## POTENTIALLY UNQUALIFIED COMPONENT IN CERTAIN ALLEN BRADLEY TIMING RELAYS

"Report of potential 10 CFR Part 21, Allen Bradley Timing Relay Model 700RTC

**UPDATE** - Report of potential 10CFR Part 21, Allen Bradley Timing  
Relay Model 700RTC  
Report No: P21-04302015, Rev. 4

Part 21 Report No: P21-04302015, Rev. 4

Figure 2 - New design circuit board and CPLD that replaced the original component.

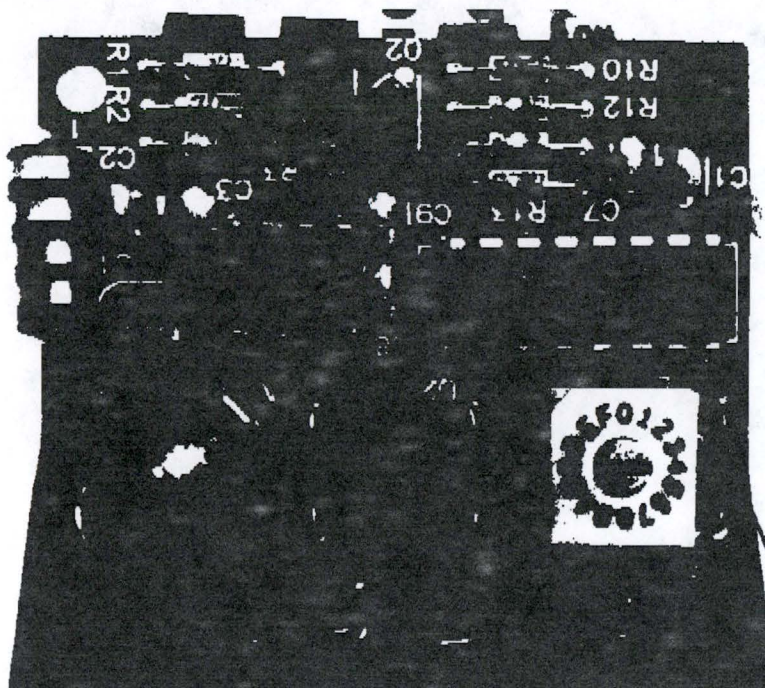
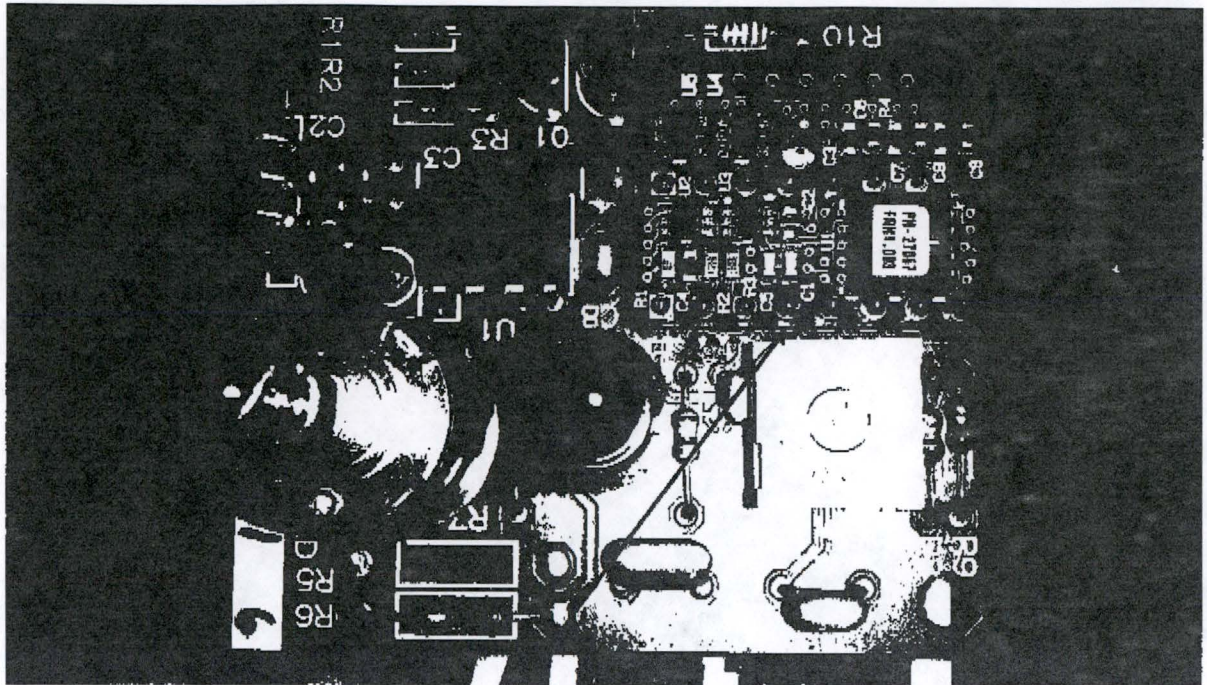
As of October 2008, Allen Bradley relays base model 700RTC, contain a CPLD (Complex Programmable Logic Device). This was an unpublished design change that was implemented to replace an obsolete integrated circuit chip. The undocumented design change did not result in a part number change from Allen-Bradley. There was no change to the appearance of the relay that would

In October 2008, Allen Bradley made a design change without changing the part number of the commercial relay or providing any documented evidence of a design change. The manufacturer specification data sheets maintain the classification that the relays are "solid state", which would imply that there are no digital devices installed in the relay. However, after inspection of the internals of the timing relay (Figure 2), it has been identified that the unit does contain a CPLD which meets the definition of a digital device under the guidance of NEI 01-01. See Figures 1 and 2 below:

Figure 1- Original qualified design (prior to October 2008).  
Relays supplied prior to October 2008 are not affected by this issue.

NLI has completed the EMC qualification testing per the requirements of EPRI TR-102323 Rev. 4 for the following tests, as applicable: CE101, CE102, RE101, RE102, RS101, RS103, CS101, CS114, CS115 and CS116.

The results were satisfactory with exception of the following condition: During Conducted Susceptibility CS114 onto the power lines, with the timing circuit in operation, the **Normally Open Timing** contact exhibited chatter (changed state) in the range of 3.3 MHz to 24.0 MHz. Supplemental testing was conducted to confirm the Timing contact was susceptible to the condition. The unit requires a ferrite to be installed onto the input power lines of the relay with 3 turns through the ferrite core. In this modified configuration, the relay was not susceptible to Conducted Susceptibility and successfully passed the required test per CS114.

The relays are dedicated for generic application usage in timing applications. The specific plant application(s) is unknown by NLI. The EMC qualification of the relay is dependent on the installed configuration and location in the plant. The plant should evaluate whether the installed relays are subjected to the specific EMI/RFI condition Conducted Susceptibility CS114 between the frequencies of 3.3 to 24.0 MHz identified above.
